Terex Utilities

PRODUCT NOTICE

PN693

SUBJECT: TL Aerial Devices on SDP Back Yard Carriers

Figure 1. Cylinder Part Number and Revision Stamp Location

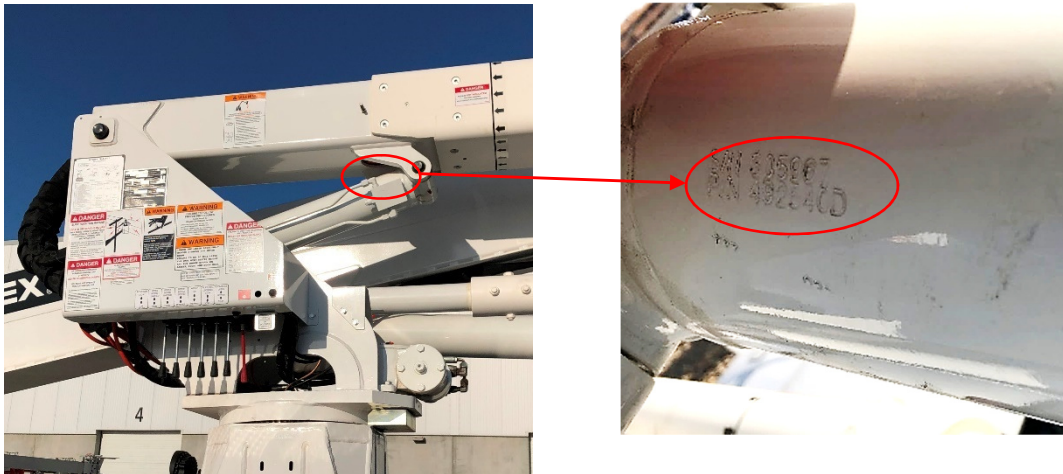
2. Inspect to determine if the lower boom cylinder is marked with the latest revision per the above table, for example 492540 Rev D. If the cylinder revision matches the above table, the rest of the Field Service Kit (basket and boom rest adjustments, decals, flow control adjustment, basket rest paint stripe) still applies. Reference Figure 1 for the location of the part number stamp.

Figure 2. Test Setup

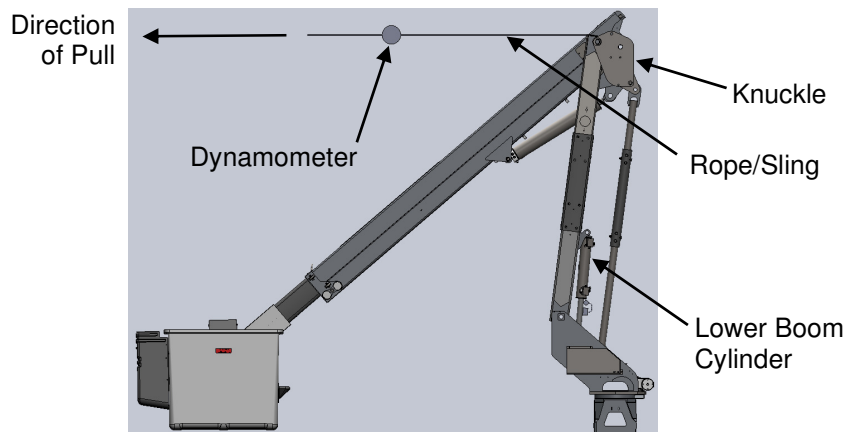
3. If the cylinder revision does not match the above table, inspect to determine if the cylinder has a loose piston nut by conducting the following test. This test must be performed once every month from the release date of this bulletin until the Field Service Kit is installed if the unit will continue to be used. If the cylinder revision matches the above table, the following test is not required, and the cylinder will not need to have the seals and locknut replaced.
 - a. Set up machine for unit use on a flat, level, and hard surface and set outriggers following all instructions in the Operator's Manual.
 - b. Connect a suitable rope or sling to the knuckle of the machine being tested so it can be pulled as shown in Figure 2.

- c. Position booms from the lower controls over the rear of the carrier so that the lower boom is fully raised and the upper boom is lowered toward the ground, similar to Figure 2.
 - d. Connect the rope/sling from Step b. to another machine (such as a bumper winch or recovery winch) with a loadcell or dynamometer visible from the ground, as shown in Figure 2.
 - e. Both machines may need to be anchored to prevent tipping.

- g. Use the second machine to create a pull load on the test machine up to 2000 pounds maximum. The direction of pull is over the top of the upper boom towards the basket using Figure 2 as reference.
- i. If during the above test the dial indicator reading exceeds .100", the cylinder must be replaced before further use.
 - ii. If the dial indicator reading is .100" or less and the machine is inspected daily, use can continue.

Figure 3. Placement of Dial Indicator

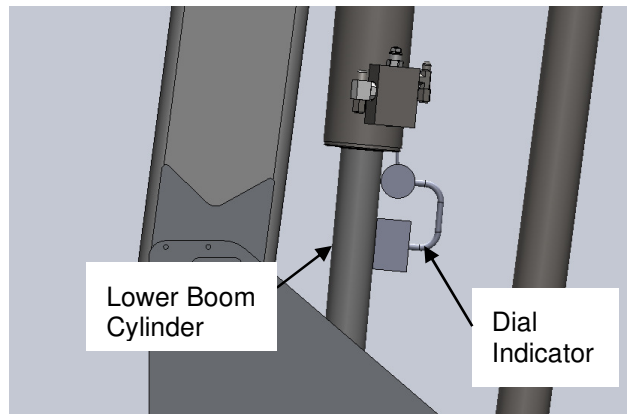
- f. Place a dial indicator on the lower boom lift cylinder rod, reading to the case of the cylinder as shown in Figure 3. Zero the dial indicator before conducting the pull test.
